SERVICE BULLETIN

No. 315

Subject: V_{ne} Airspeed Limit

Models Affected: PA-30 Twin Comanche

SK-2202

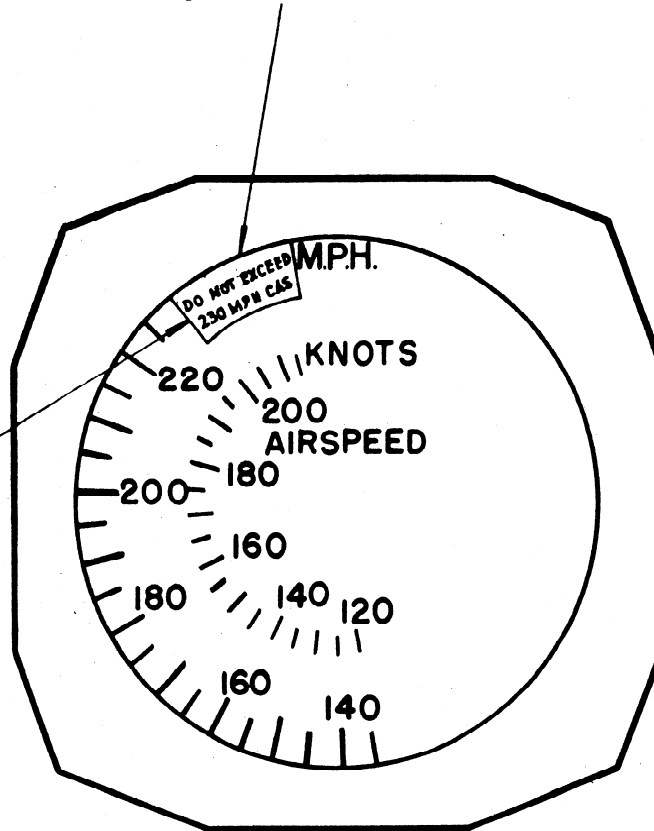
Purpose: To revise the existing V_{ne} Airspeed Limit of 245 mph C.A.S. to a V_{ne} Airspeed Limit of 230 mph C.A.S.; reference FAA Airworthiness Directive dated July 2, 1970.

Instructions: Install airspeed indicator placard part number SK-2202 on the face of the airspeed indicator, as denoted by the sketch on the reverse side of this bulletin.

Install Placard SK-2202 on the face of the Airspeed Indicator as shown.

Locate this edge of Placard SK-2202 at 230 M.P.H.
